Service Bulletin

Bulletin No.: 08-08-57-003B

Subject: Floor Wet Under Carpet/Engine Continues to Run with Key Off/Possible No Crank/No Start/Communication Loss/Various Electrical Concerns (Seal Seam)

Models: 2008 Buick Enclave
2007–2008 GMC Acadia
2007–2008 Saturn OUTLOOK

2125552

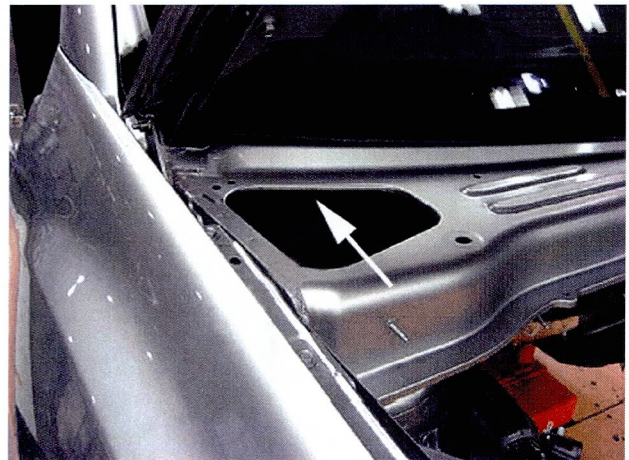
Water from the right front sunroof drain hose exits the vehicle through the plenum (upper arrow) and may re-enter through the un-sealed seam at the front of the dash. Refer to lower arrow in the illustration.

2125557

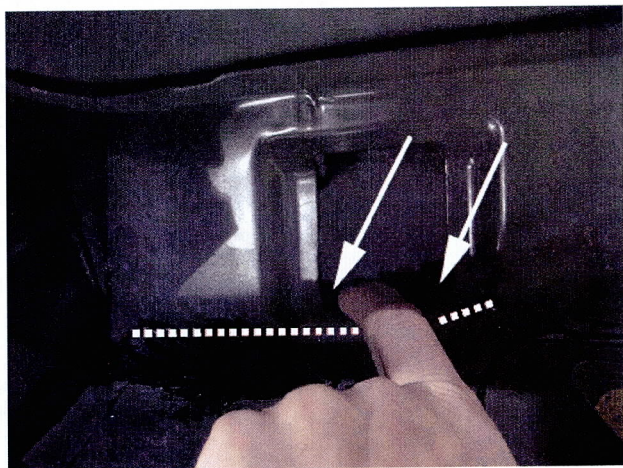
1. Remove the windshield wipers and cowl screen where sealing repair is to be done.

Important: Inspect the IP BEC for wetness and/or any green colored corrosion.

2. In order to verify the waterleak, run a small amount of water into the square hole inside the cowl while looking at the IP BEC.
3. Allow the water to dry and proceed to step 4.

4. Seal the seam **INSIDE** the opening at the bottom and to the right and left of the arrows in the illustration. Seal the full length of the dotted line. Seal the seam with P/N 12378500 (in Canada, use 10952233) Medium Body Seam Sealing Compound or equivalent.
